# **Design Guide for Open Rack Management Backplane Connection (v. 0.52):**

Q & A from Boston Open Rack Workshop Presentation  
*October 9<sup>th</sup>, 2015*

Compiled by: Ethan Long, Intel

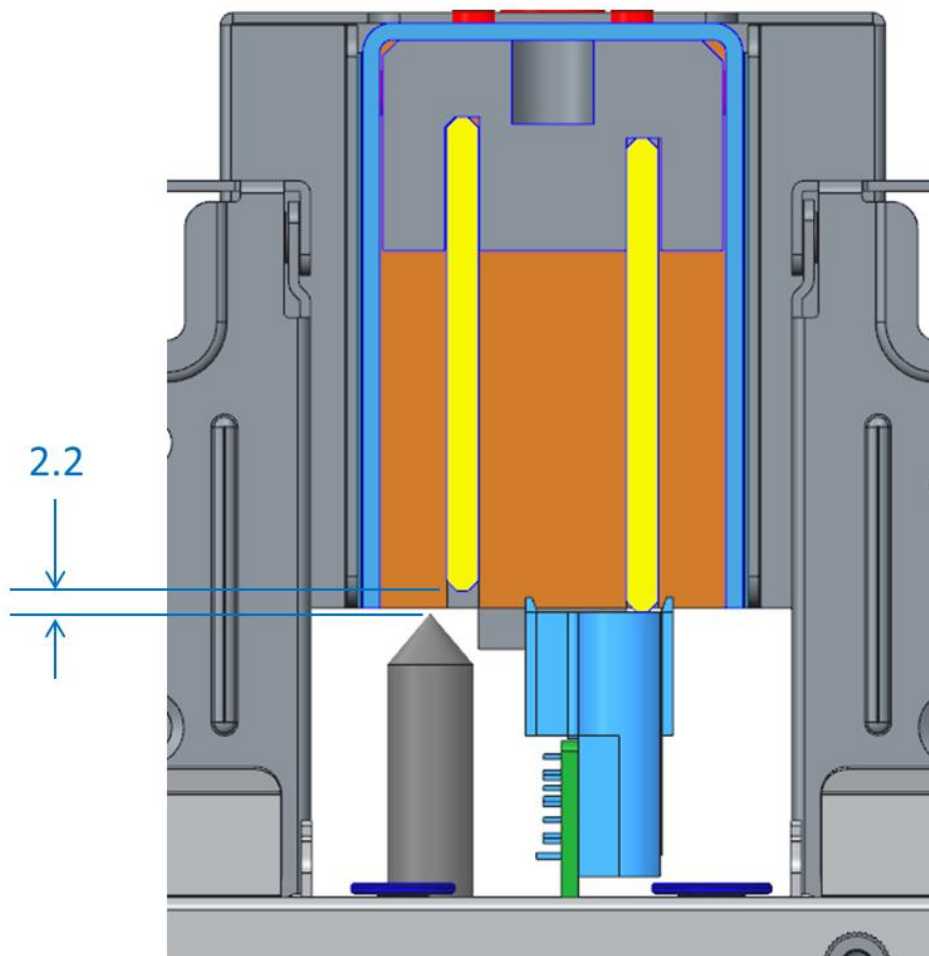
### **2) What are the tolerance requirements for the IT equipment making the MBP connection?**

The overall tolerances required to maintain a reliable connection vary with rack and IT equipment design, and it was not the intent of the design guide to specify a requirement here. However, Intel can help define a requirement if there is continued interest in including a management backplane in the Open Compute standard.

The connectors themselves can resolve up to 2 mm of X-Y misalignment during docking. However, the Intel/Quanta implementation is designed to tolerate up to 4 mm of X-Y misalignment through the use of the additional coarse alignment pins. The design guide will be updated to include the allowable misalignment in the Intel/Quanta implementation.

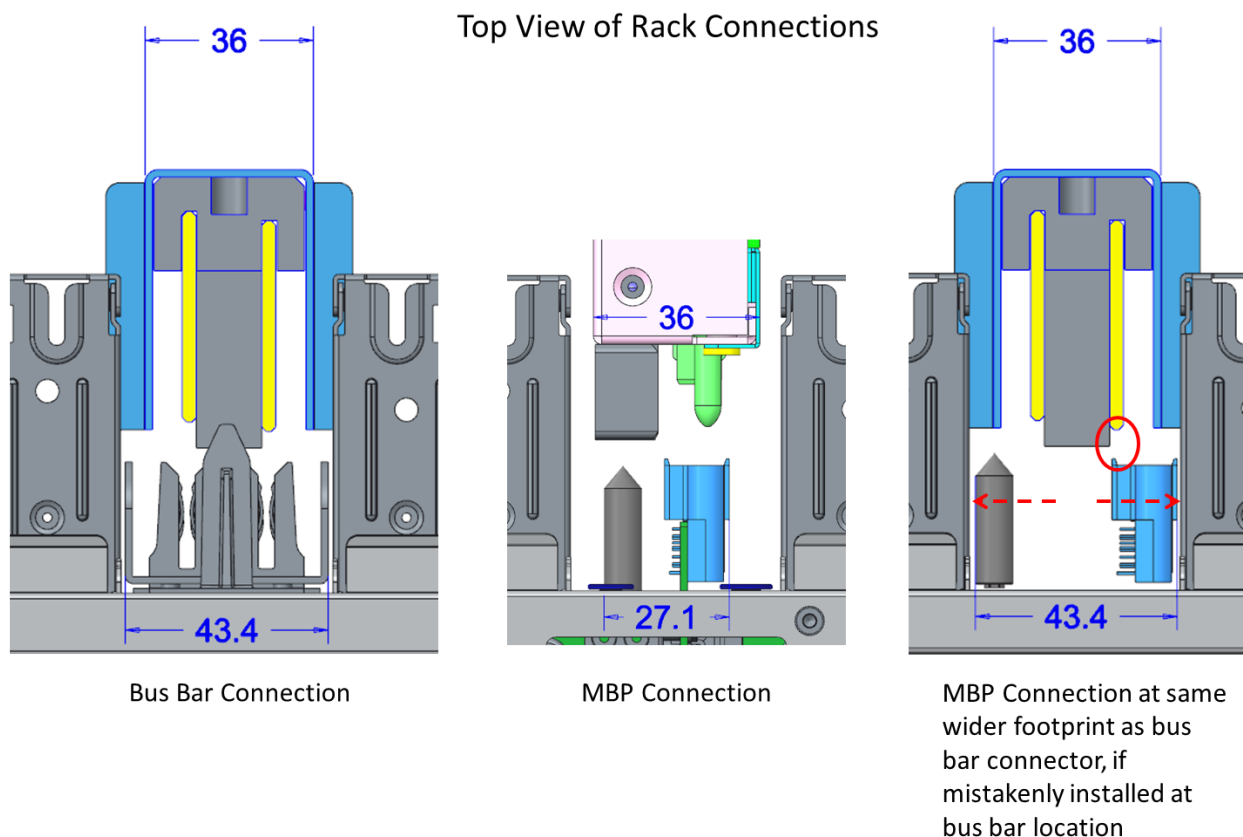
### **4) The bus bar connectors extend to the sides past the bus bar space. Can that space also be used to possibly avoid bus bar contact (see previous question)?**

No. The bus bar connector assemblies used on the demo systems, at 43.4mm, are wider than the MBP connector assembly, and the rack's 36mm-wide bus bar zone. Given this, the server-side connector and alignment pin mating locations may theoretically be spread wider to avoid bus bar contact altogether, but the management backplane in the rack will then exceed the 36 mm zone width specified in the Open Rack standard. Also, the Intel/Quanta implementation has optional fan mounting locations on either side of the management connection that prevent a wider backplane footprint. If the footprint could be set to the same width as the bus bar connector, the alignment pin would be at less risk of contacting the positive bus bar, but the MBP connector would still impact the negative bus bar. See the images below for a comparison of the various connections.
